DATE ISSUED September 26, 2014

ADDENDUM # 2

PROJECT LPS Security/Technology Ready Facilities – Project F

ETI PROJECT # 2014-028

169.T01B

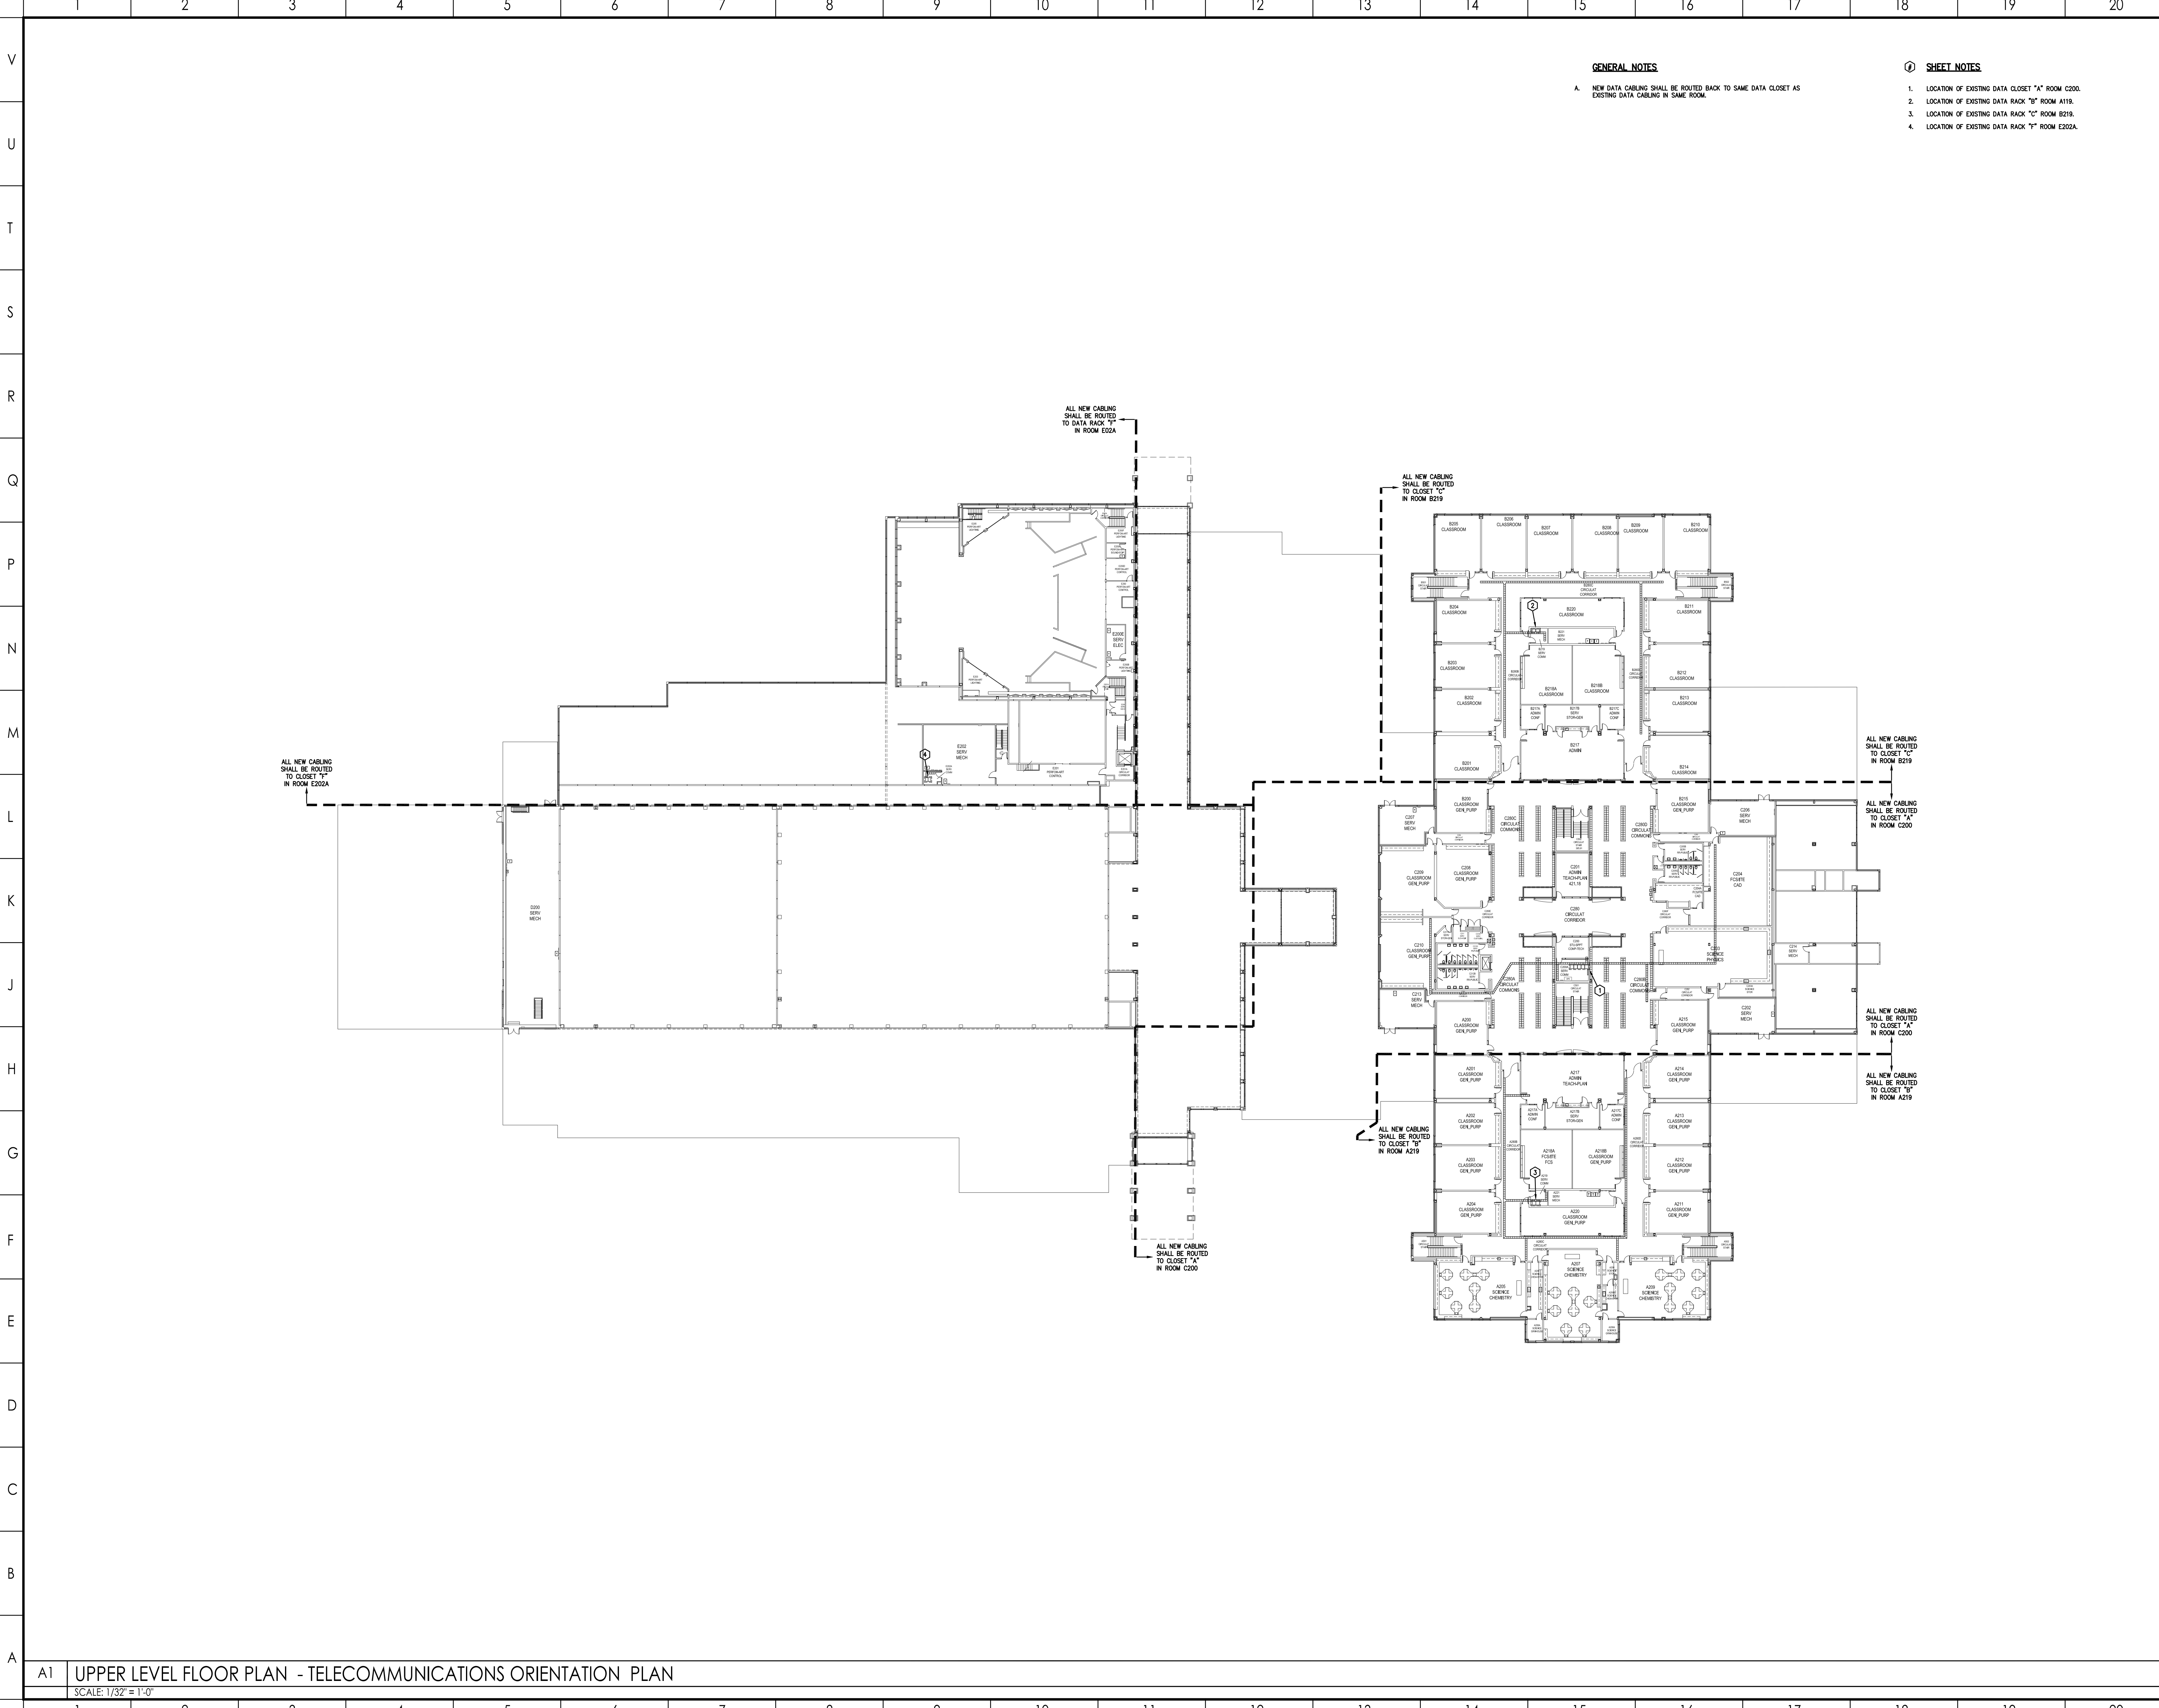
1. Sheet 169.T01B
 - A. Multipurpose 105 – See attached drawing for clarification of projector cabling.
 - B. SPED 112
 - i. The Note 11 in the south end of this room does not have a leader arrow. The note shall point to the existing data outlet with two existing cables located on the east wall adjacent to ALE112A.
 - ii. Change the Gear Box to 2,1 in lieu of 2,2.
2. Sheet 169.T21
 - A. Detail A1 - Provide an additional wire management above new Cat6 patch panel.

305.T00C

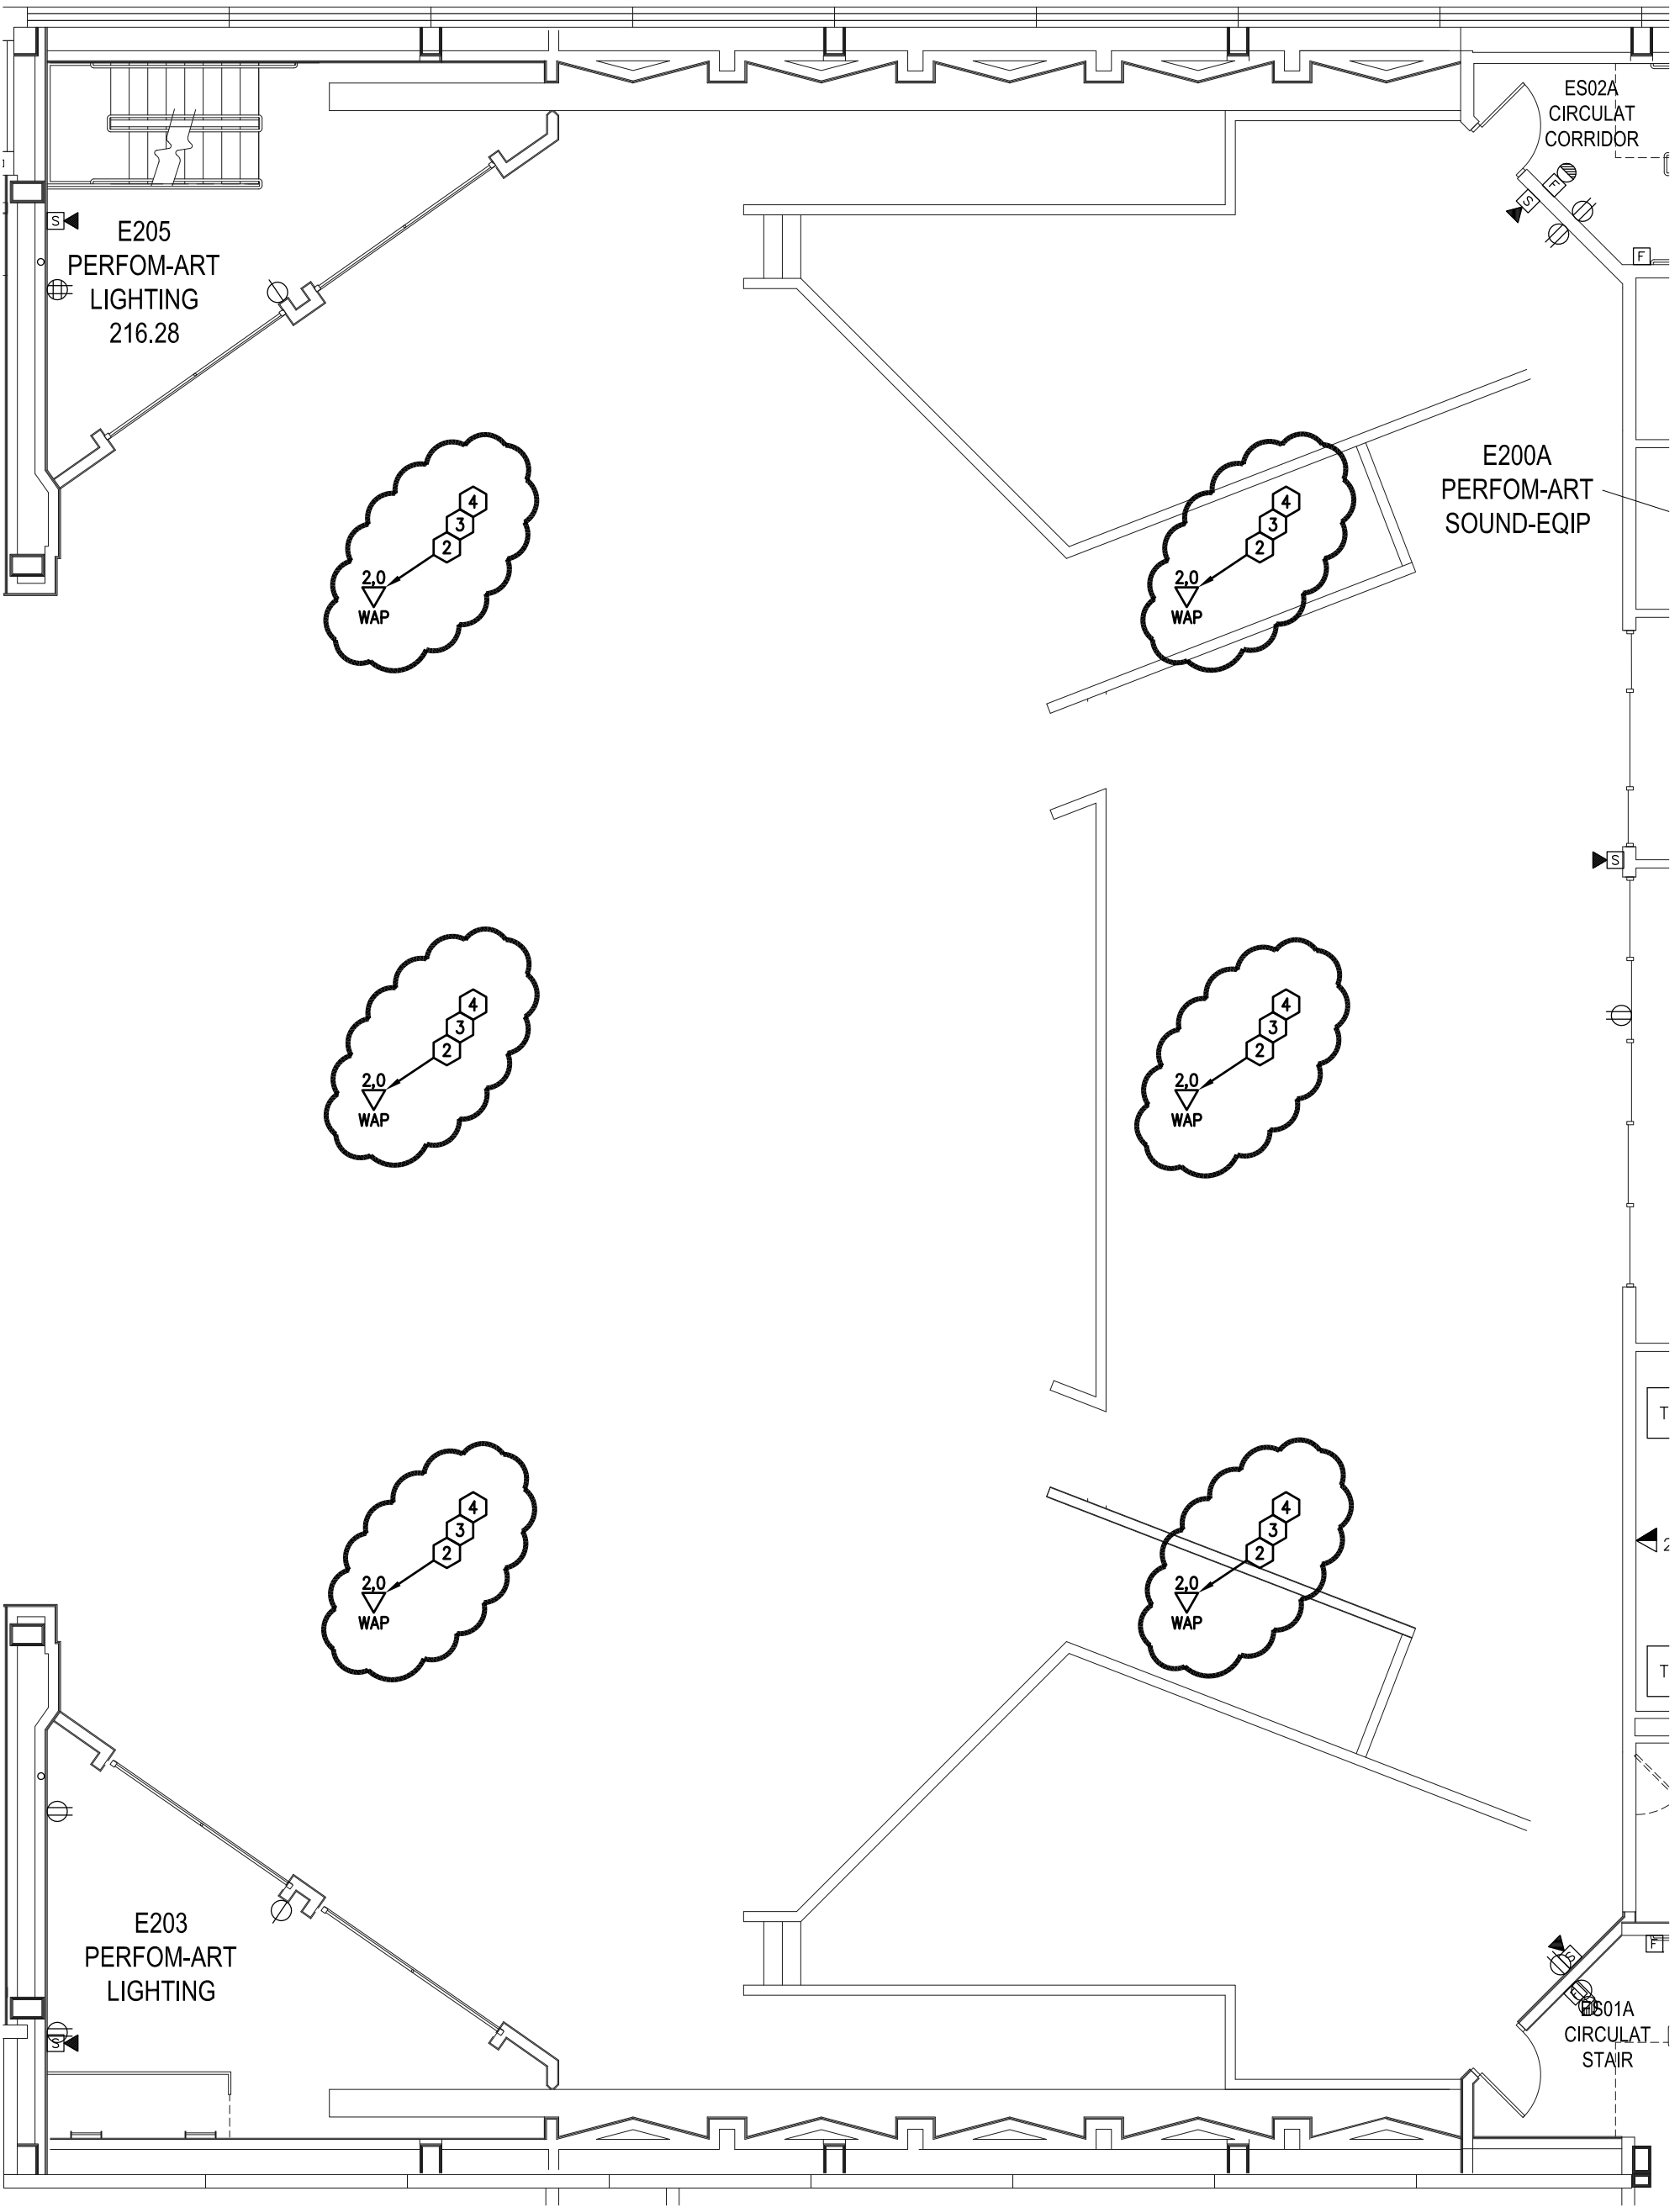
2. Sheet 305.T00B – In the center core all cabling north of the elevator, Rooms C101 thru C110, shall feed from Serv Comm C200A.
3. Sheet E305.T00C – See attached drawing for data boundaries.

ADD #2
 SHEET
305.T03B
 ATTACHMENT NO.
 1
 09/26/2014

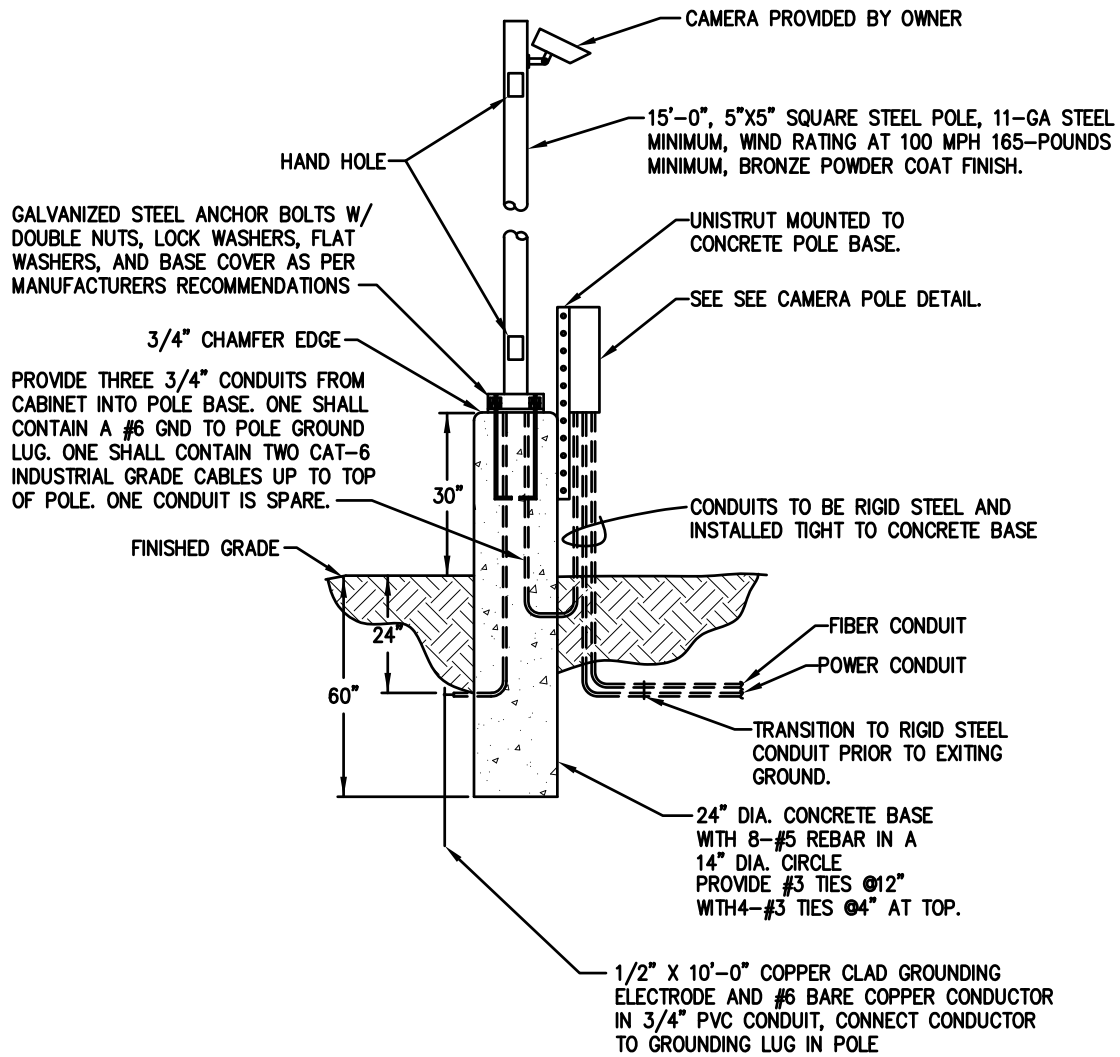
7. Sheet E3058.T02G – Reception C101 the WAP should indicated 2,0.
8. Sheet E305.T03B
 - A. Relocate WAP from E200E to E200.
 - B. See attached drawing for new layout of WAPS in Auditorium.

TYPICAL POLE MOUNTED CAMERA DETAIL

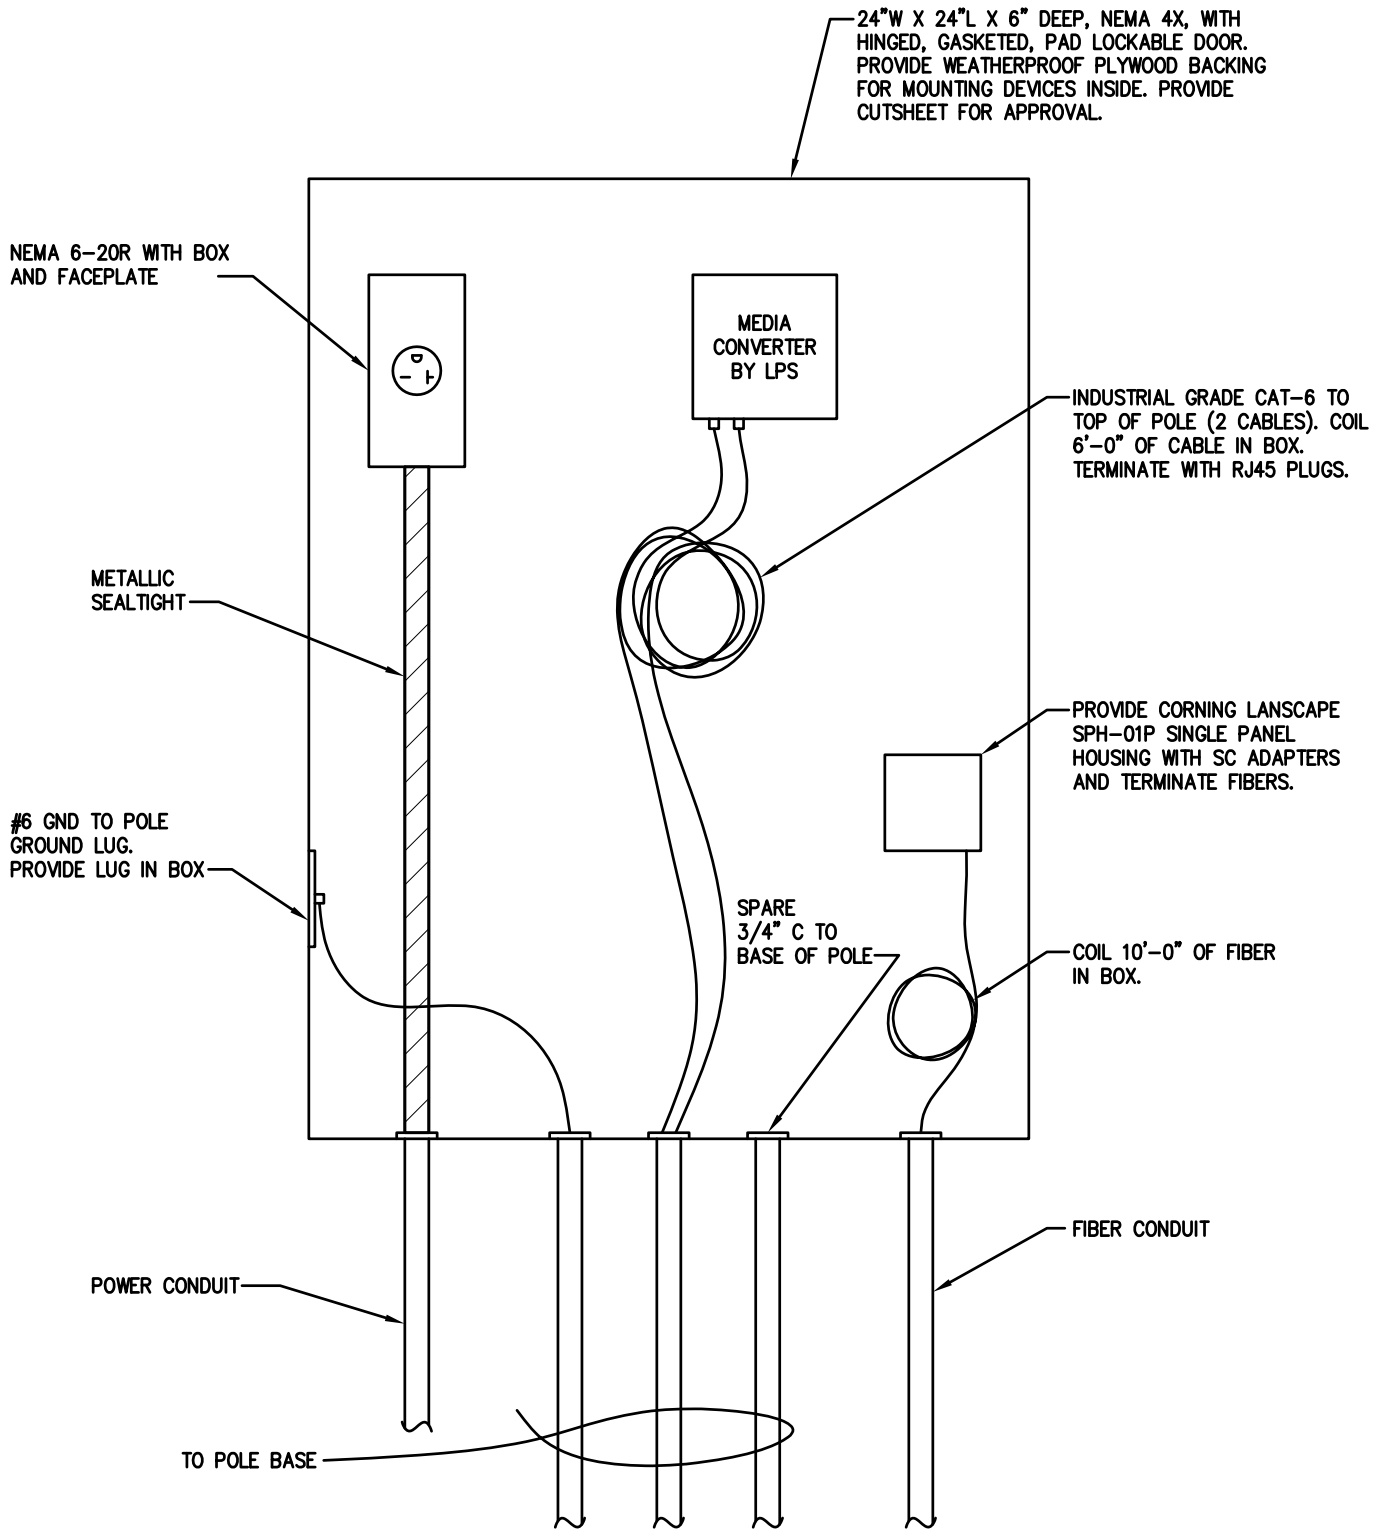
10. Sheet 305.TS00
 - A. The outside fiber cable indicated in Notes 2 and 4 shall be rated Indoor/Outdoor cable OM3 and OM4 respectively.
 - B. The circuits to the camera poles may be bored using Schedule 40 HDPE.

- C. See attached details for camera pole and camera pole cabinet.
